**CITY OF BERKELEY**  
**SANITARY SEWER REHABILITATION PROJECT**  
**PARNASSUS ROAD, ET AL.**

SPECIFICATION NO. 23-11548-C  
**ADDENDUM NO. 2**

The City of Berkeley has revisions, and/or additions on the following Plan Sheets in the Contract Plans for Specification No. 23-11548-C, Sanitary Sewer Rehabilitation Project – Parnassus Road, et al.:

SANITARY SEWER REHABILITATION  
40 STEVENSON AVE  
PLAN AND PROFILE

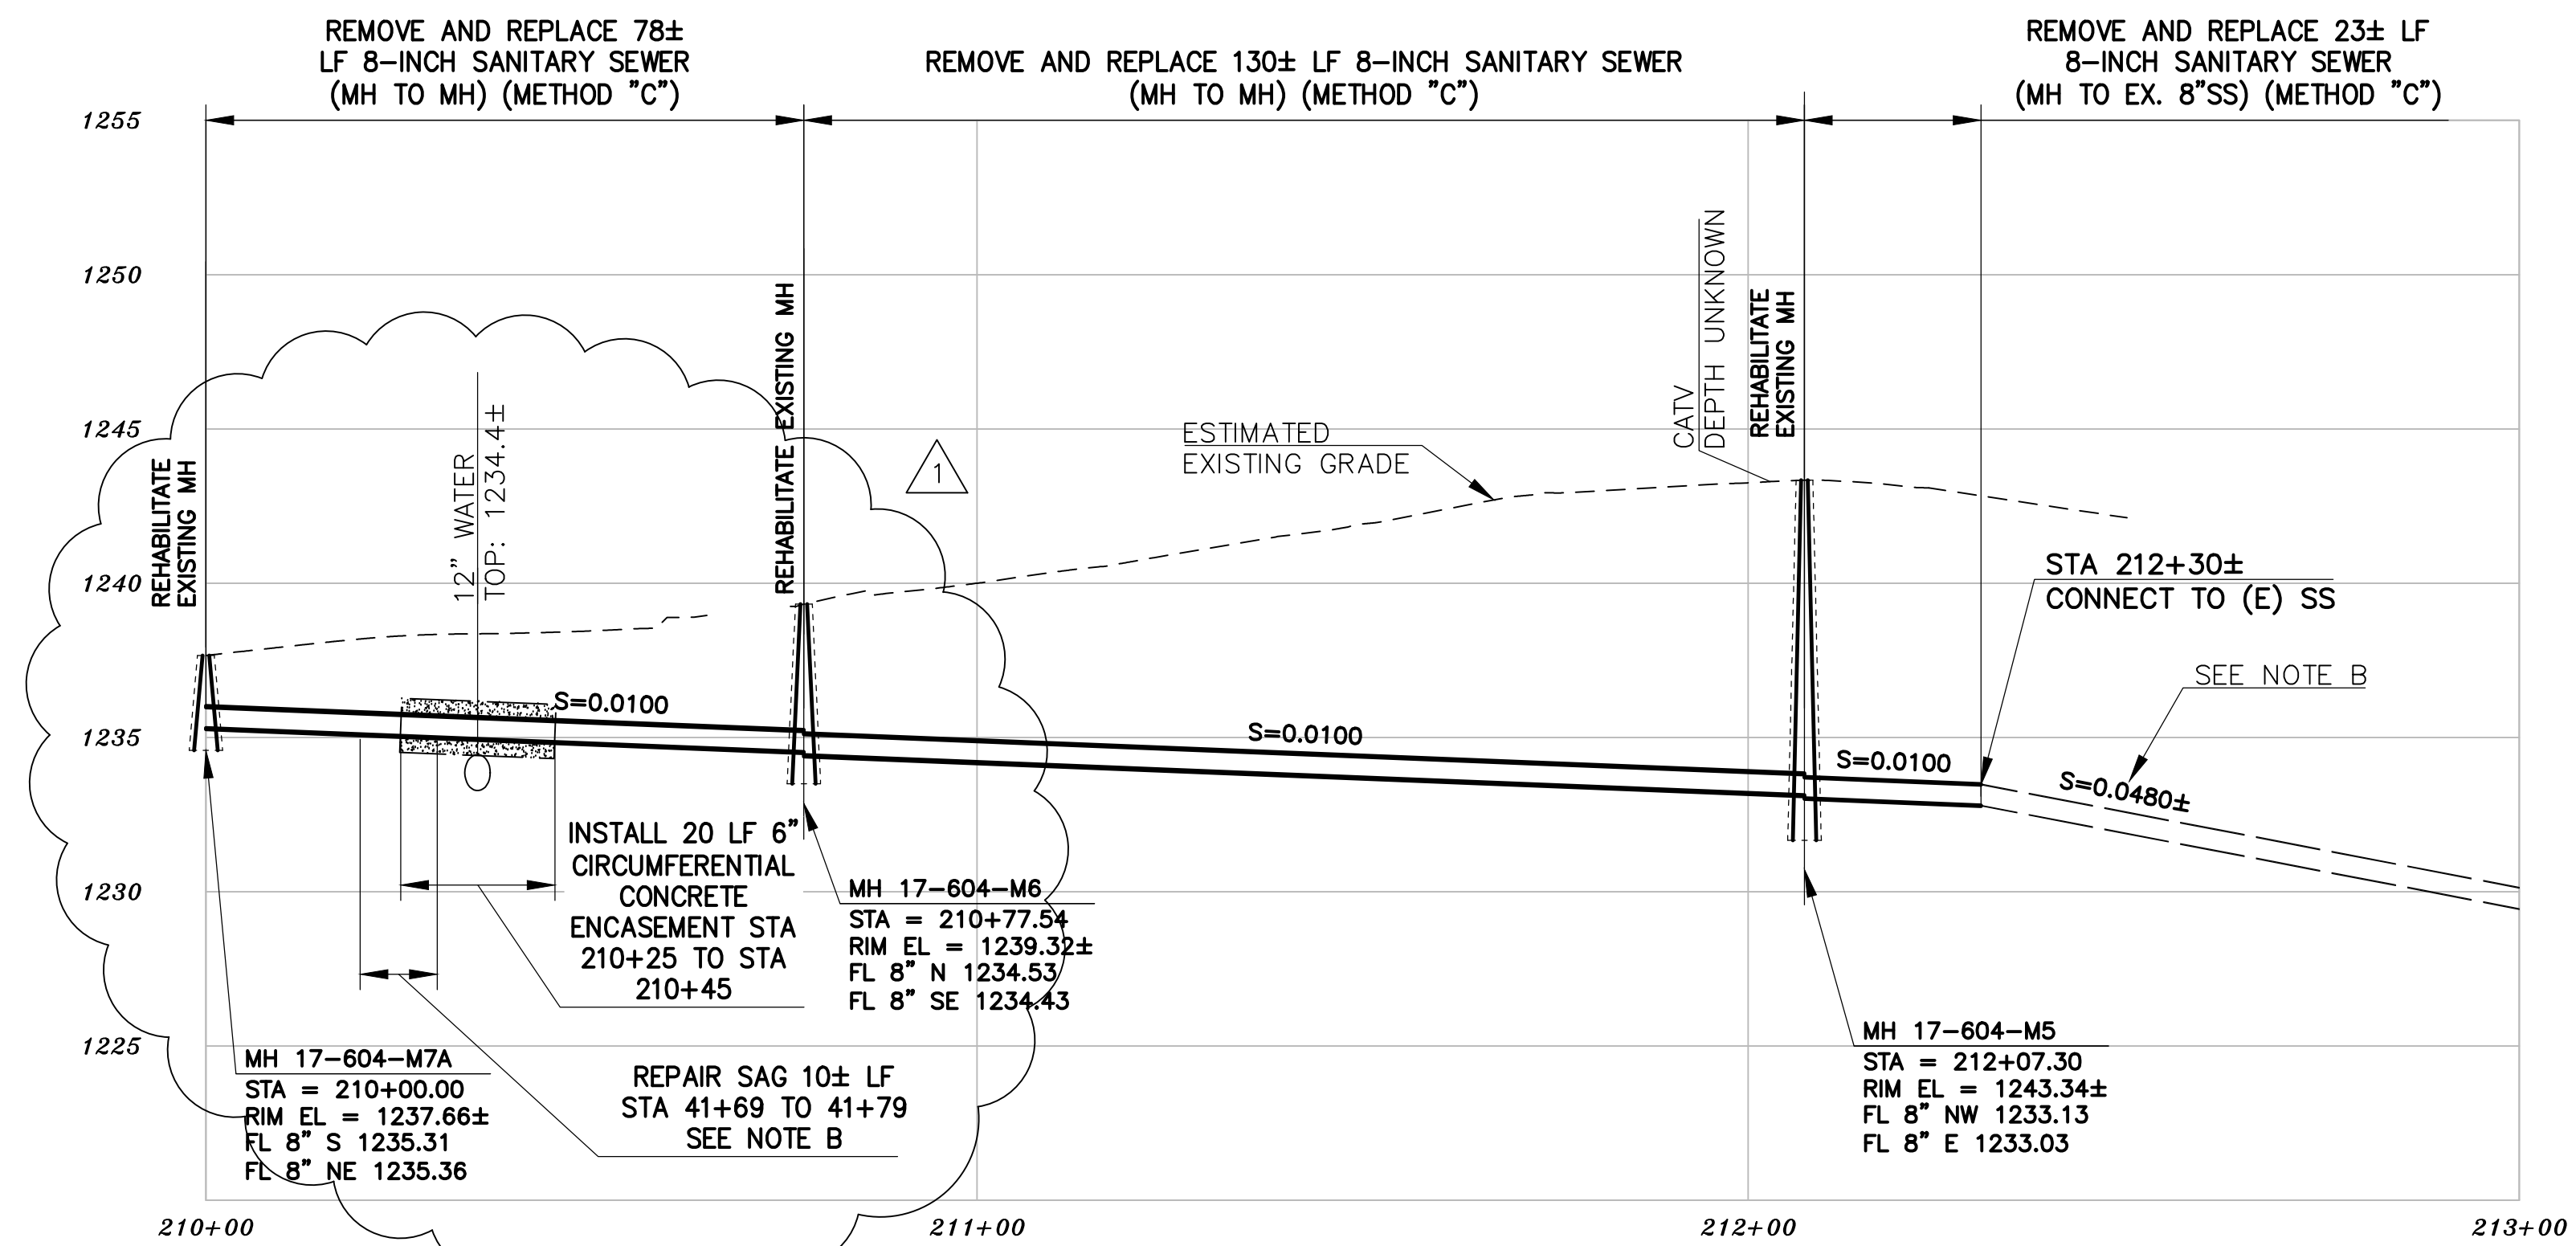
- WORK SHOWN ON THIS SHEET IS LOCATED IN CITY OF BERKELEY FIRE ZONE 2 AND IS SUBJECT TO ALL WORK REQUIREMENTS AND RESTRICTIONS.
  - REPAIR LATERAL CONNECTION 5± LF STA 130+35± TO 130+40± (METHOD "C").

- FILL VOIDS CAUSED BY RUNG REMOVAL WITH NON-SHRINK GROUT.

- Sheet 19** - Stevenson Ave from MH 17-701-30 to MH 17-701-28
- Sheet 20** - Stoddard Path and Grizzly Peak Blvd from MH 17-702-35 to MH 17-702-39
- Sheet 22** - Sterling Ave at MH 17-702-21

SANITARY SEWER REHABILITATION  
**1462 CAMPUS DR**  
PLAN AND PROFILE

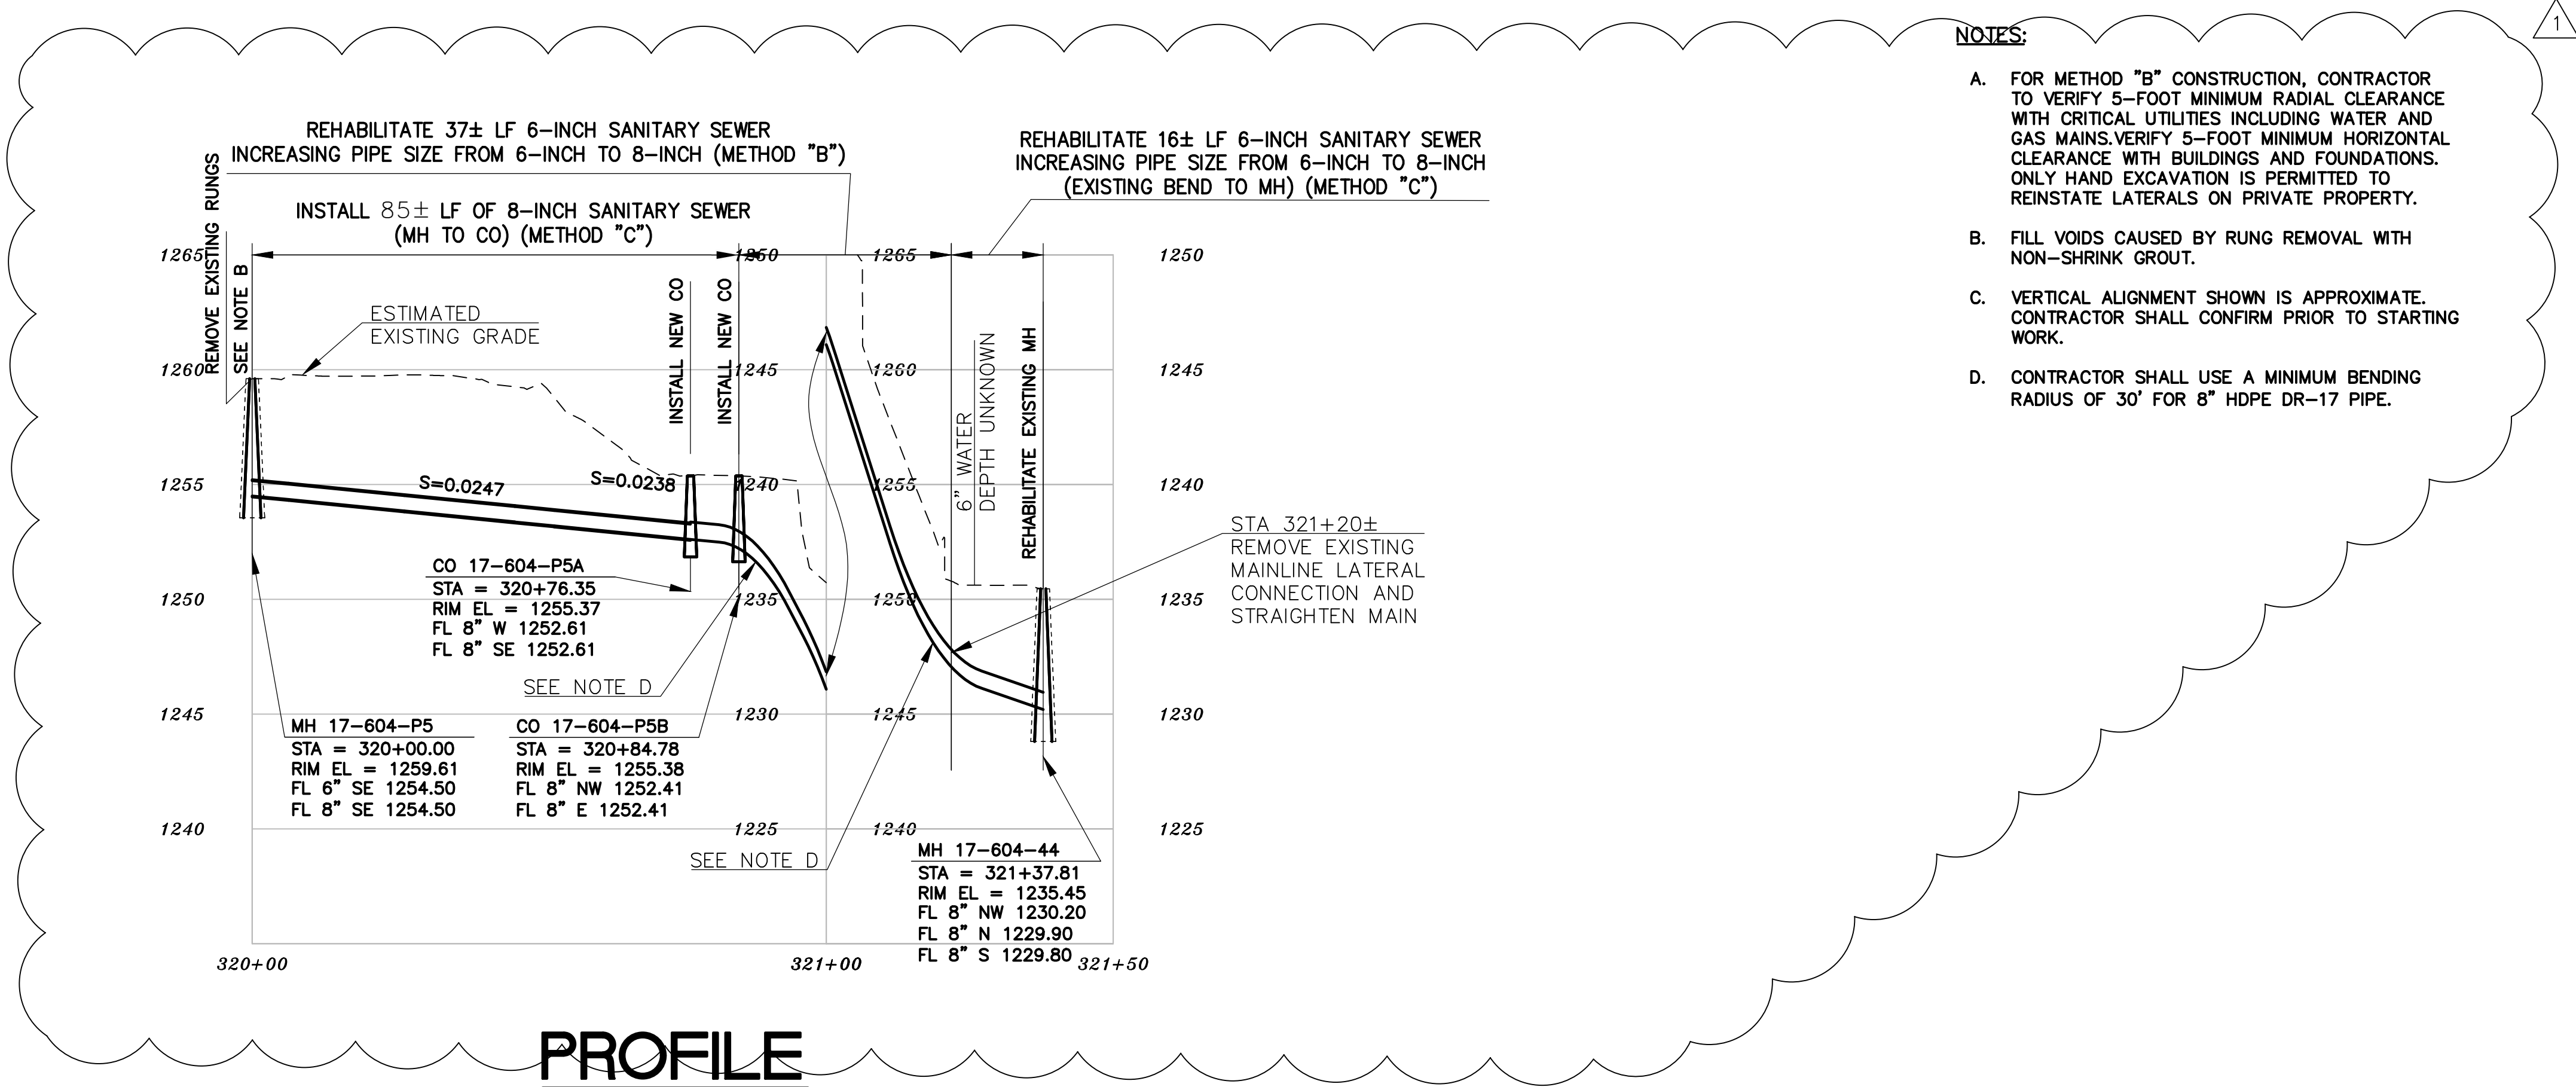
**Revise** Special Condition No. 41 to add Sheet 11 – Latham Ln and Creston Rd from MH 17-713-B2 to MH 17-713-17 and remove Campus Dr at MH 17-702-A4 and MH 17-605-87.

- RELOCATE MH 17-605-87 AS NECESSARY TO CONNECT 1462 CAMPUS DR AND 1456 CAMPUS DRIVE LATERALS TO NEW STRUCTURE.

- ~~Sheet 23 - Campus Dr At MH 17-702-A4 and MH 17-605-87~~
- Sheet 24** - Shasta Rd from MH 17-702-72 to MH 17-702-31
- Sheet 29** - Fairlawn Dr from MH 17-604-K1 to MH 17-604-K2

SANITARY SEWER REHABILITATION  
**96 TAMALPIAS RD**  
PLAN AND PROFILE

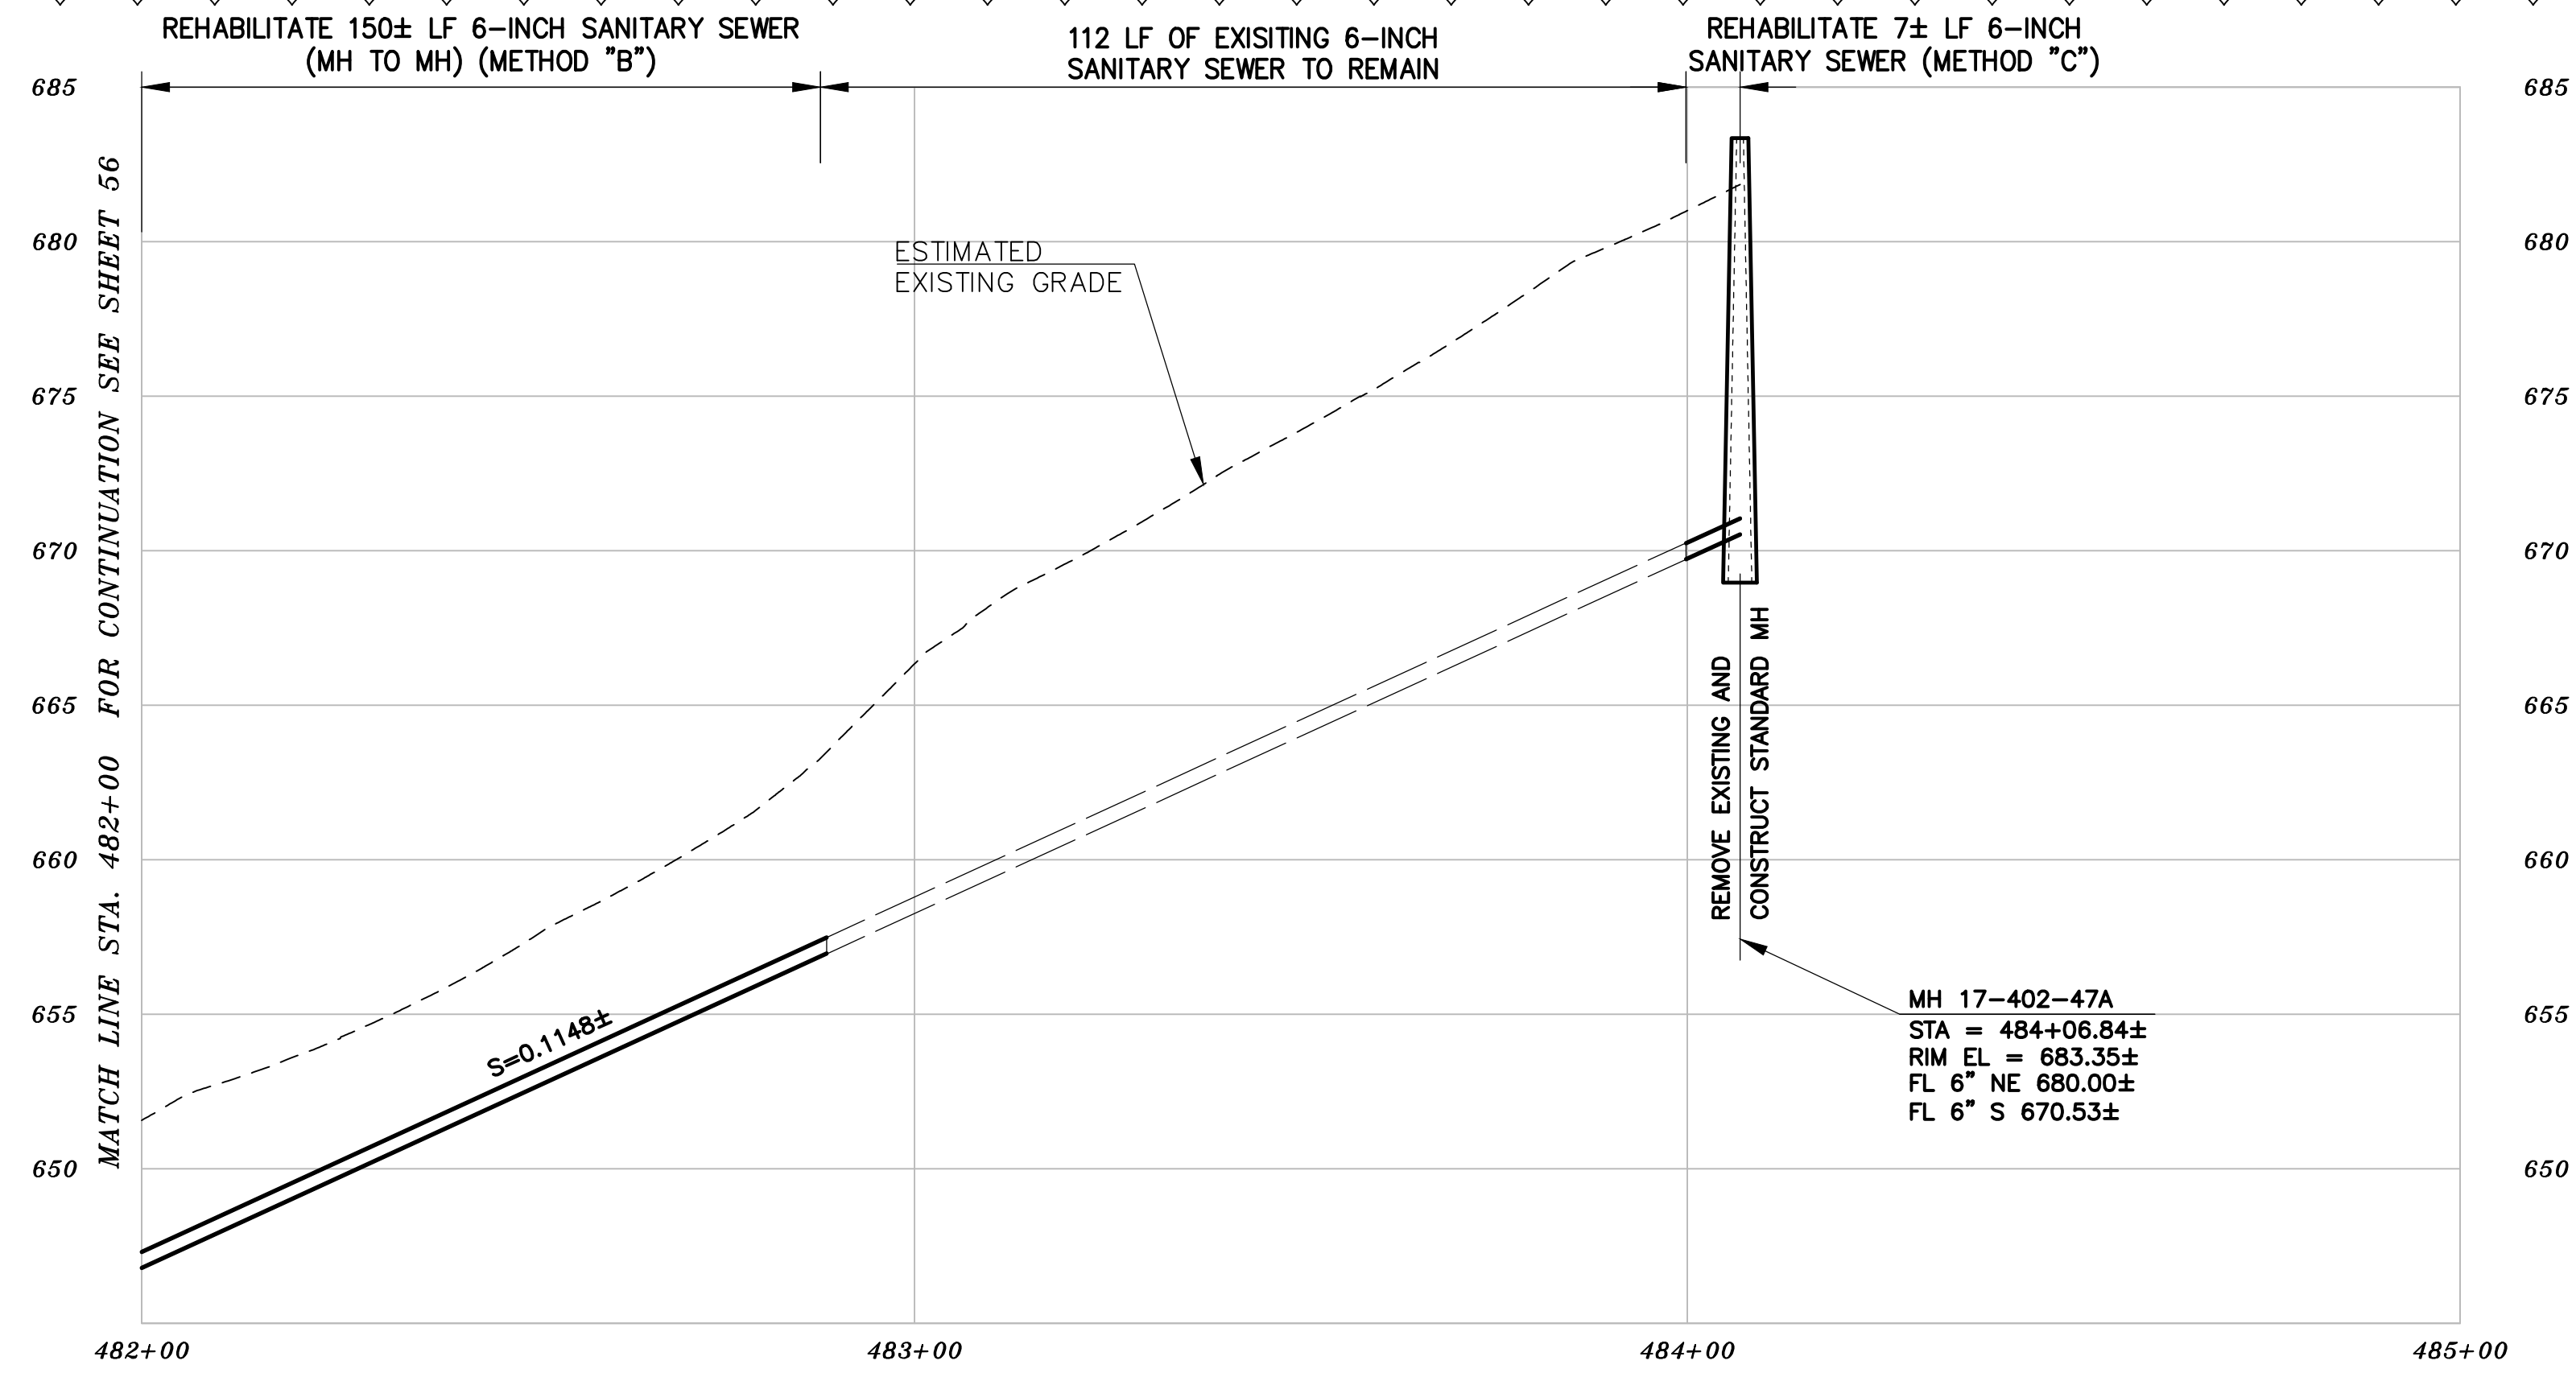
- WORK SHOWN ON THIS SHEET IS LOCATED IN CITY OF BERKELEY FIRE ZONE 2 AND IS SUBJECT TO ALL WORK REQUIREMENTS AND RESTRICTIONS.
- REMOVE AND REPLACE 6-INCH VCP SANITARY SEWER STA 460+00± TO 460+10± (METHOD C) GRADE BREAK AT 460+07±.
